LONG CHIH INDUSTRIAL COMPANY LIMITED
101, Show Shan Road, Shinchuang City, Taipei Hsien, Taiwan, ROC
Tel: 886-2-29068666 Fax: 886-2-2906-8669 E-mail: longchih@ms31.hinet.net

SAFETY RECALL NOTICE

Long Chih – trailer manufacturer has decided that all our trailers manufactured from September 1, 2005 to December 31, 2008 fail to conform to Federal Motor Vehicle Safety Standard No. 110. "Tire Selection and Rims." These trailers are missing the tire placard label which states the tire size, tire pressure, and maximum load information. The gross vehicle weight rate (GVWR) on the VIN plate on some of the trailers is incorrect and the GVWR and gross axle weight rate (GAWR) units should be specified in pounds on the VIN plate. Also, the owner's manual is missing the information to report suspected safety defects as required by Federal Regulation Title 49 CFR Part 575 "Consumer Information." A misprinted label could lead to improper vehicle loading specification or tire inflation which could result in a tire failure, increasing the risk of a crash.

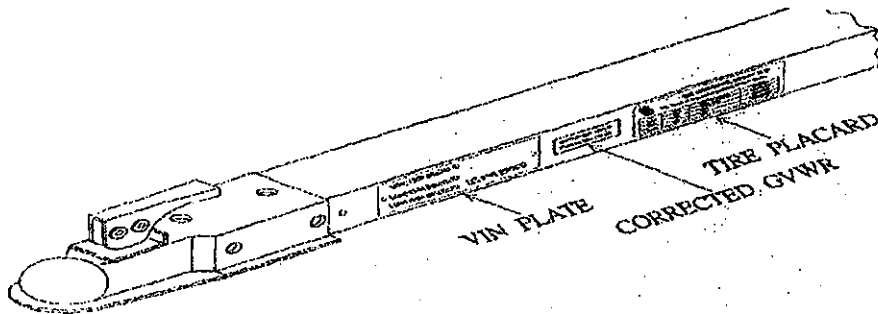
Enclosed with this letter is the correct tire placard label and GVWR label. Please affix these labels to the driver's side of the trailer tow bar near the VIN plate as shown below in this picture. Also enclosed is the "Reporting Safety Defects" statement as a part of owner's manual. Please read this statement and save it with

1. Clean the surface of the tow bar driver's side as on above diagram.
2. Please affix the provided corrected GVWR label first then tire placard on clean surface of tow bar.
